<u>Subject: Tonto Recreation Alliance Objections to the Draft Record of Decision and Final</u> <u>Supplemental Environmental Impact Statement – dated October 4, 2019</u>

Please find below comments from the Tonto Recreation Alliance (TRĀL) on the Final Supplemental Environmental Impact Statement ("FSEIS") issued by USFS in October 2019.

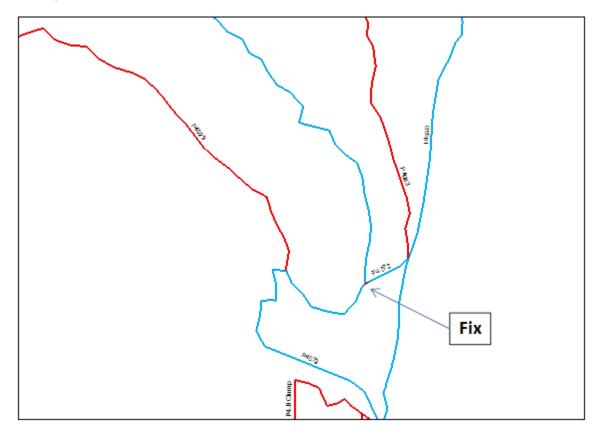
<u>Sugarloaf Motorized Trail Error</u> - There appears to be an error in the GIS database on one section of route P4072. The northern part of this ATV route is shown in the Alternative 2 map as open for Motorized Trail but a small section on the southern end which connects the route to FR1855 is shown as closed.

Specific Request - Correct the GIS database and maps to designate P4072 as open for all vehicle types all the way to FR1855.

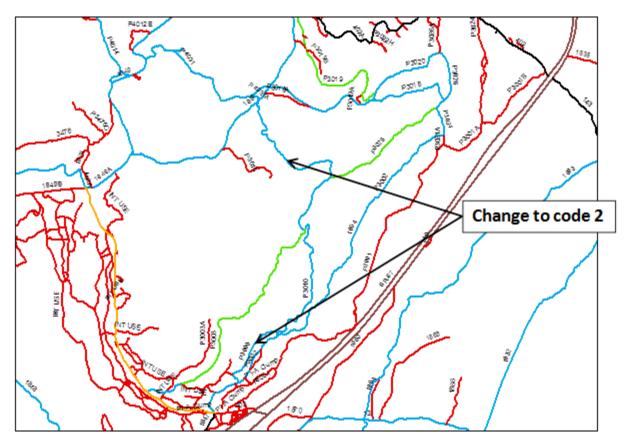
<u>Rock Stars ST vs. MT error</u> - P3010 and P3009 for their entire length are in reality and in the original inventory database a single track motorcycle trail measured at 0.5 to 1 meter in width. P3003 is NOT motorcycle single track but is instead an ATV width wash. This error needs to be corrected since these trails will eventually be signed for motorcycle use only.

Specific request - Change coding of P3010 and P3009 from ATV/Motorized Trail to Motorcycle Trail (change from Scoping code 3 to 2 in GIS database). Change P3003 from Motorcycle Single Track to ATV/Motorized Trail (Code 3).

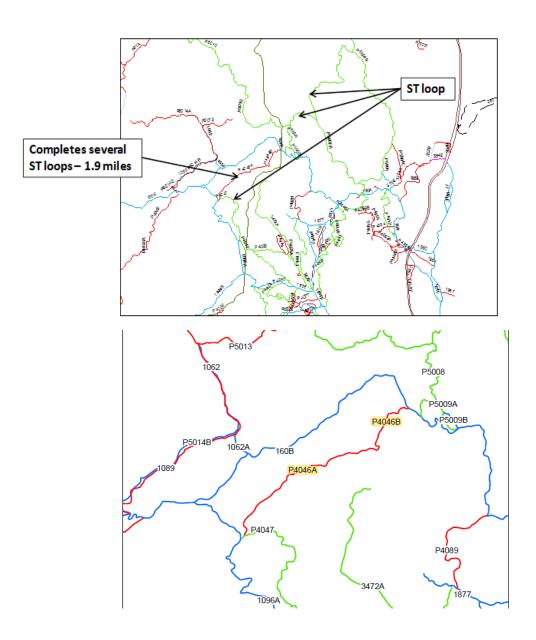
<u>Upper Two Gates Trail</u> - There is an important section of single track motorcycle trail that is currently proposed to be closed consisting of P4046A and P4046B (commonly called Upper Two Gates trail). The route is part of a very popular motorcycle single track loop in the Sycamore Creek route system. With this segment of motorcycle single track missing, the loop is incomplete and leaves dangling segments on both ends. Closing this segment is completely illogical given the decision to keep the single track trails on both ends of it open.

Specific request - TRAL requests that P4046A and P4046B be changed from Decommissioned to Motorcycle Trail.

Slate Creek – Route

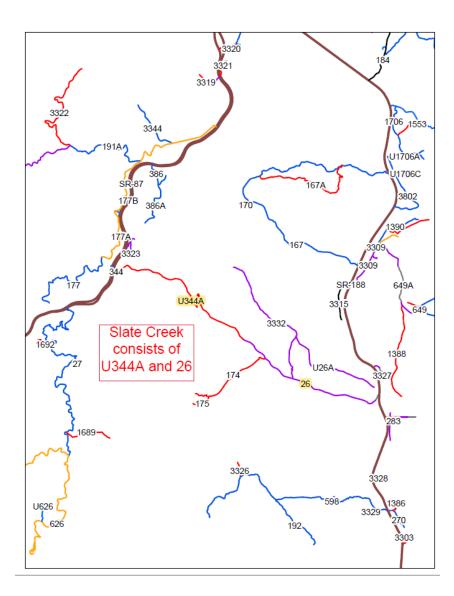
First, we believe that the numbering of Slate Creek may be incorrect. From the history of the Slate Creek route it seems almost certain that the combination of what is being called U344A and 26 should be 26 for its entire length. This stretch was part of the original Bush Highway connecting the Phoenix area to Payson. TRĀL has started working with the Tonto National forest on a set of projects that, in addition to enhancing the OHV recreation experience, would help to preserve more of the forest and state's history. The fascinating history of Slate Creek is a big part of why TRĀL would like to see this route left open for motorized travel.

Specific Request – Change U344A and 26 from Decommission to Motorized Trail. Evaluate changing U344A to 26.

U2256A and U2256 Route Issue (TRAL Objection #24)

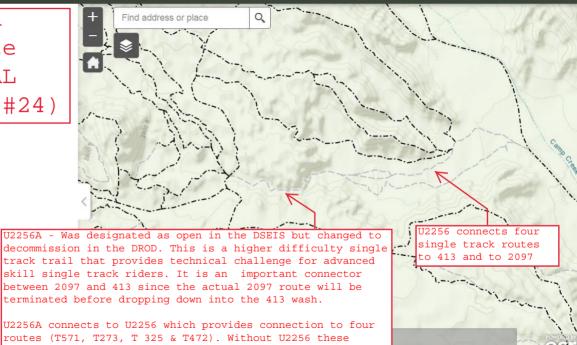
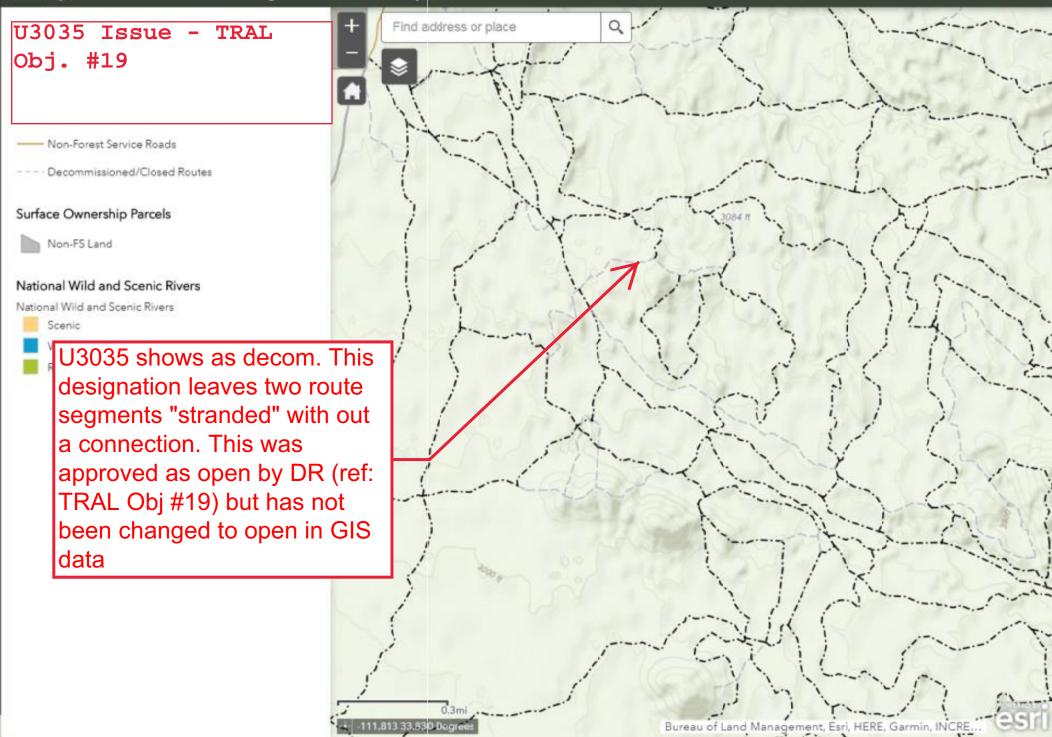
U2256A/U2256	Wildcat	Decommission	Open - single track TRĀL Objection #24	Agreed change in DSEIS not made in DROD/FSEIS story map. Please note that this decision leaves several routes dead-ending into U2256 with no outlet . U2256 provides an outlet to FR413 and U2256A (Ref TRĀL Objection #24 DSEIS)
U2259 & U3024	Wildcat	Decommission	Open – single track, TRĀL Objection #28	Agreed change in DSEIS not made in DROD/FSEIS story map. No rational provided for changing this route back to decommission from open – ST so it is assumed that this is an error translating the DR decision into the GIS data. (Ref TRĀL Objection #28)
T221/ID2154	Wildcat	Open – full size	Open – single track	FSEIS story map still shows this route as full-size,

routes dead-end with no outlet
